CR Number
07-21815

TITLE: EXPONENT FAILURE ANALYSIS REPORT CLARIFICATIONS REQUIRE FENOC TECHNICAL REVIEW

Clarifications of the Exponent Report

Response to NRC 5/14/07 DFI Letter Request B

Figure 1. Boric acid and iron oxide deposits on Davis-Besse reactor pressure vessel flange at 12RFO. [Root Cause Report – Figure 4, page 91 and Exponent Report, Section 4, Figure 4.1, page 4-23].

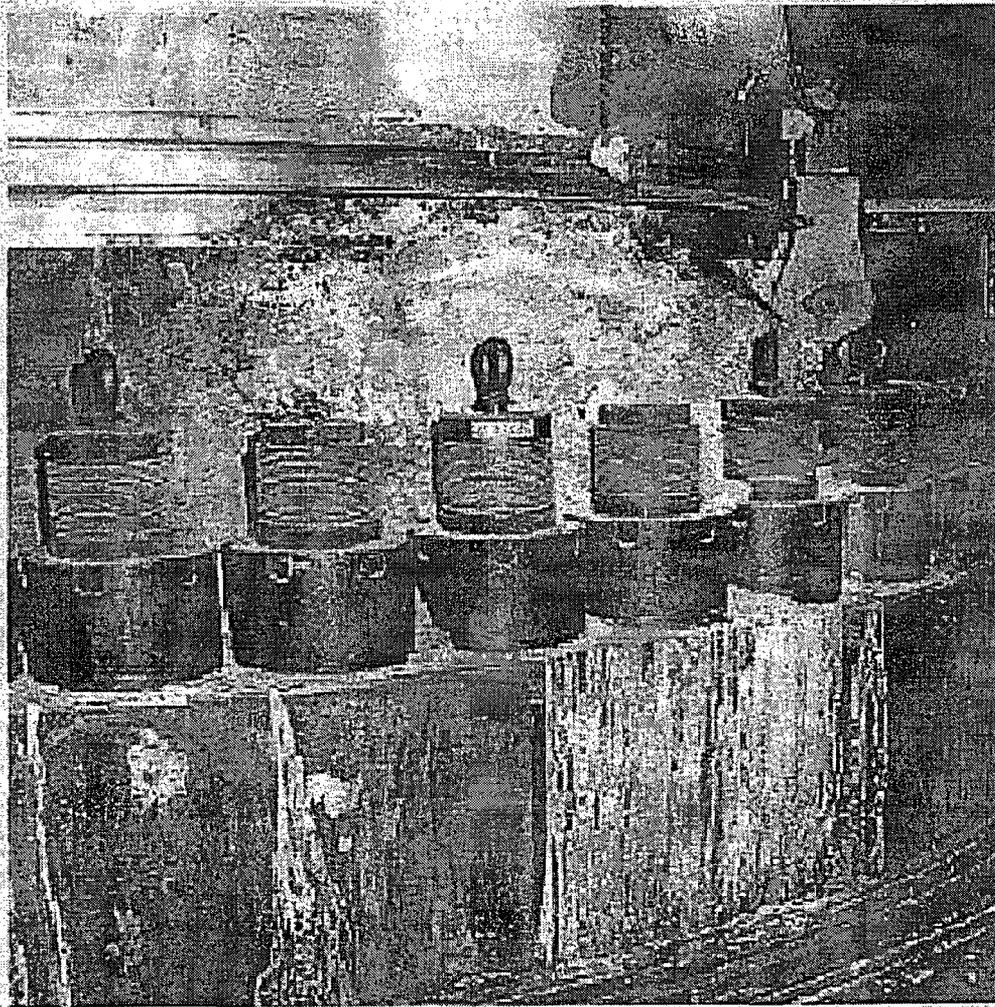
The Root Cause Report notes that boric acid deposits were observed flowing from the RPV head service structure mouse holes down the outside surface of the reactor vessel head to the RPV flange area at both 11RFO in 1998 and 12RFO in 2000. The Root Cause Report further notes that the boric acid was a "reddish rusty color", indicative of corrosion of the RPV head. A photo of the deposits at 12RFO is included in both the Root Cause Report and the Exponent Report (attached here as Figure 1).

The Root Cause Report apparently interprets these "red" colored boric acid deposits as being indicative of iron oxide from RPV head corrosion due to leakage from CRDM nozzle cracks at Nozzle 3. However, Exponent concluded that the unqualified assumption that the "reddish rusty color" of the deposits shown in the 12RFO photo was the result of corrosion due to boric acid leakage from a CRDM nozzle crack is

unwarranted. First, as discussed earlier, the Exponent analysis shows that at 12RFO in April-May, there was no significant leakage and no extensive boric acid deposits resulting from the axial crack at CDRM Nozzle 3 prior to 12RFO. Therefore, the "red" colored boric acid shown in the 12RFO photo could not have come from this crack, and neither could the "red" colored boric acid reported at 11RFO in 1998, when the Exponent CGR analysis showed that the crack at Nozzle 3 had not even reached the top of the weld.

After 9RFO in 1994, difficulty was experienced at 10RFO, 11RFO and 12RFO in completely cleaning boric acid deposits from the RPV head, especially near the center nozzles where the clearance between the RPV head and the insulation was small. Thus throughout this time period, boric acid deposits were continually present on the Davis-Besse RPV head. Any boric acid deposits remaining on the RPV head at the completion of an outage would become molten when heated to reactor operating temperatures, and would flow slowly down the head and out of the mouse holes during normal operation, thereby resulting in the deposits observed at 12RFO shown in the Figure 1 photo.
